Lifetime extension of the
French 1300 MWe reactor fleet
generic requirements for the
4th periodic safety review

Task 3: Hazards Report

REPORT
REP-0936

Figure 2: Locations of the 1300 MWe reactors on the background of the French active fault database

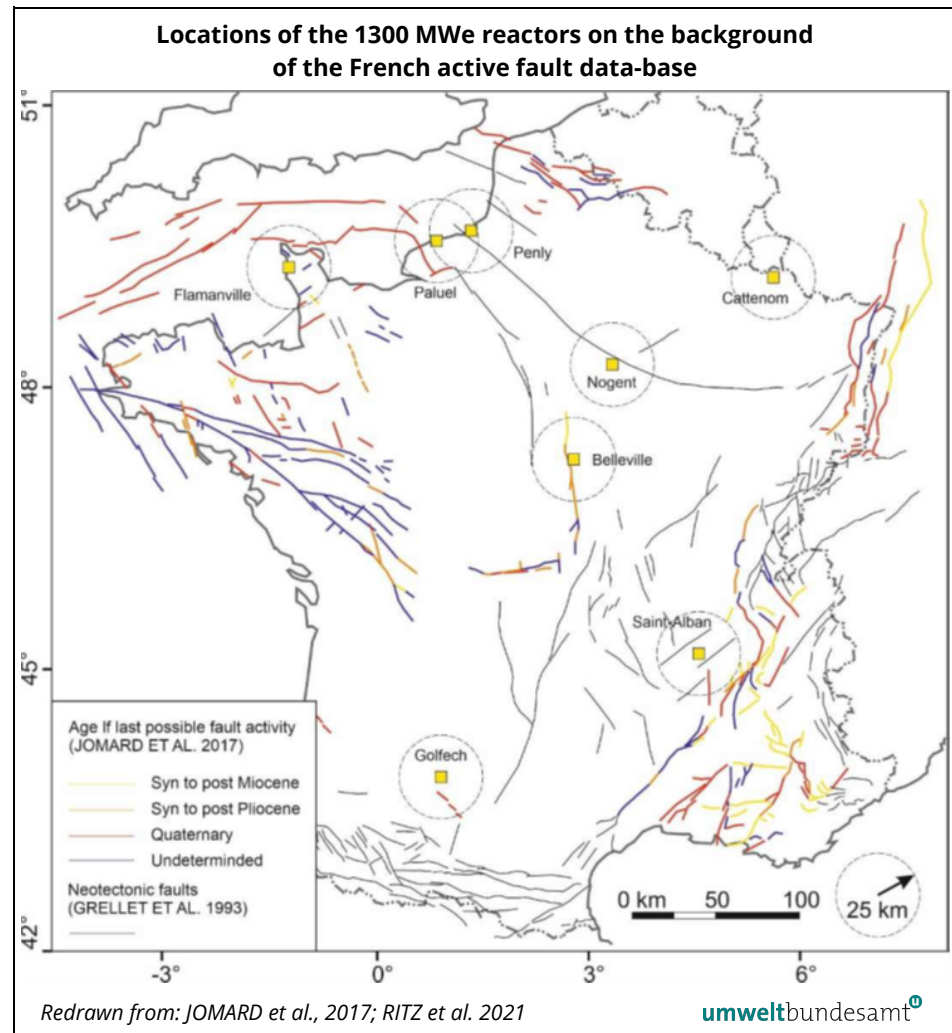
Figure 2 shows the locations of the 1300 MWe reactors on the background of the French active fault database. The importance of considering fault information is particularly evident for the sites Belleville, Flamanville, Golfech, Paluel and St. Alban, where Pliocene and/or Quaternary faults extend to distances of less than 25 km from the plants. It is noteworthy in this context that ASN has already prescribed how to incorporate fault data in the PSHAs for establishing the HSC of the 900 MWe reactors Fessenheim and Tricastin (ASN 2018).
